Our ref: LTR-NRC-08-36
August 22, 2008

Subject: Follow-Up Response to the Second Round of NRC's Request for Additional Information by the Office of Nuclear Reactor Regulation for Topical Report (TR) WCAP-16747-P, "POLCA-T: System Analysis Code with Three-Dimensional Core Model" (TAC No. MD5258) (Proprietary/Non-Proprietary)

**LTR-NRC-08-36 NP-Enclosure, Follow-Up Response to the Second Round of
NRC's Request for Additional Information by the Office of Nuclear Reactor
Regulation for Topical Report (TR) WCAP-16747-P, "POLCA-T: System
Analysis Code with Three-Dimensional Core Model"
(TAC No. MD5258) (Non-Proprietary)**

Figure 1, Comparison of Zirconium Metal-Water Oxidation Kinetics

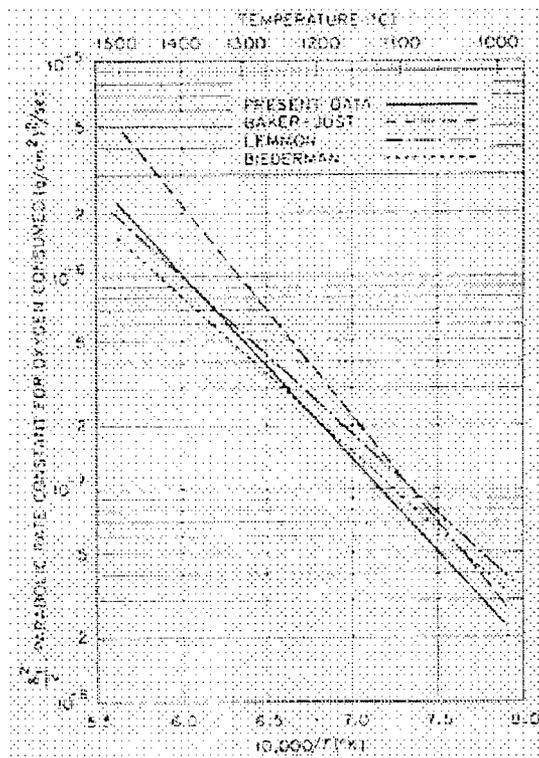
- (1) Again, cladding reaction with coolant is alloy specific. Please appropriately identify any and all alloys.
- (2) For each alloy identified in (1) immediately above, please verify the validity of this section's equations versus experimental data.
- (3) Please justify why the Baker-Just model is adequate for POLCA-T.
- (4) Is the Cathcart-Pawel model not applicable or necessary?
- (5) The first sentence of this section refers to Baker-Just; the second to last sentence of this section refers to Cathcart-Pawel for values of constants. Please clarify.
- (6) Please explain why cladding thermal properties do not change as oxide layers develop.

- 2) The plot in Figure 1 from Reference 1 shows that the reaction rate for total oxygen uptake is clearly higher for Baker-Just than for other expressions all of which are in good agreement with data.

It can be noted that the oxidation kinetics at high temperatures (more than 900°C) are barely dependent on the alloy type. For operating temperatures (about 300°C) the oxidation rate varies considerably depending on alloy type and on water-chemical conditions; however, these differences are only important if they alter the initial conditions for transients. For high temperature transients only the high temperature oxidation kinetics are of interest.
